**E-16: Wurzbach Parkway Sewer at Highway 281
Solicitation Number: CO-00325
Job No.: 18-4509**

**ADDENDUM 1
June 2, 2020**

SHEET
SEWER DETAILS (SHEET 1 OF 2)

2 TEE BASE FIBERGLASS MANHOLE LID DETAIL

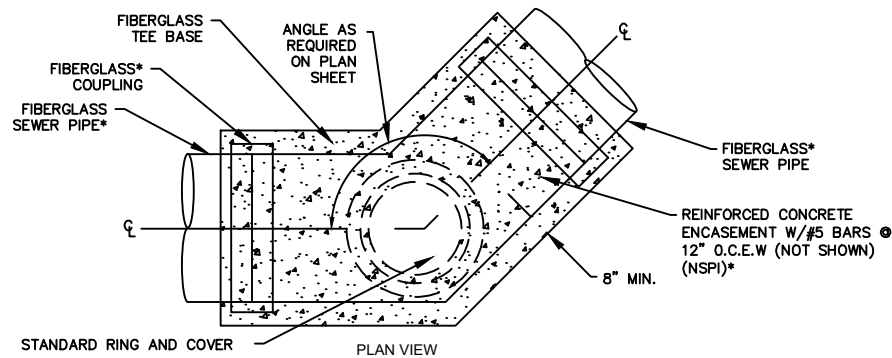
Q1: **The 48-inch ring and cover show on the plan details sheet C34 is not an approved ring and cover for SAWS use.**

Response: *The following products have been approved by SAWS for use on this project. Sheet C34 has been updated.*

- *Neenah Foundry – R-1741 755B Double Lid*
- *Neenah Foundry – R-6099 T10 Single Lid*
- *SIP Industries – 2351 SAWS Double Lid*
- *SIP Industries – 2351 SAWSS Single Lid*

- MANHOLE LID SHALL CONFORM WITH SAWS SPECIFICATION 852.
- SAWS PRODUCT STANDARDS COMMITTEE HAS APPROVED THE FOLLOWING MANHOLE RING AND COVER PRODUCTS FOR TESTING ON THIS PROJECT:
 - NEENAH FOUNDRY - R-1741 755B DOUBLE LID
 - NEENAH FOUNDRY - R-6099 T10 SINGLE LID
 - SIP INDUSTRIES - 2351 SAWS DOUBLE LID
 - SIP INDUSTRIES - 2351 SAWS SINGLE LID

1 TEE-BASE FIBERGLASS MANHOLE DETAIL

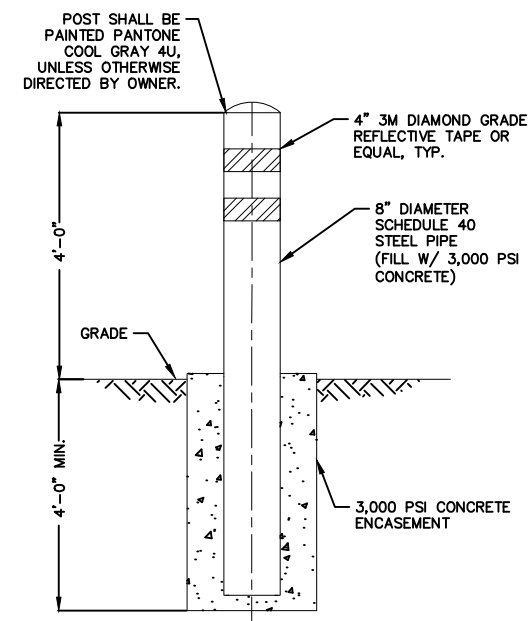
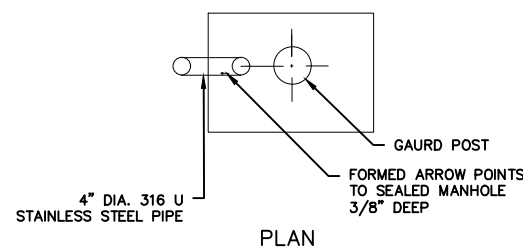
Q2: **We are being told by our fiberglass manhole manufacturer that when opening the throat of the manholes and riser section to 48-inch clear opening per the plans they can no longer maintain H20 load rating the maximum clean opening to maintain H20 rating is 38-inch clear opening. Seeing as many manholes are in the roadway this could be a very large issue.**

- Q11:** **Please confirm which manholes will require a 48-inch ring and cover? Where required, will the ring and cover encasement follow 852-03 or will a top slab be required as shown on Sheet S1, MH-05A?**

Response: *In discussions with manufacturer during design 48-inch clear opening as shown on plans is feasible while still maintaining H20 rating.*

- Response:** *Ring and cover encasement for outlet and inlet structure shall be per detail on S1 and S2. All other manholes shall have ring and cover encasement per SAWS standard construction detail DD-852-03. Only tee-base manholes will require 48-inch ring and cover.*
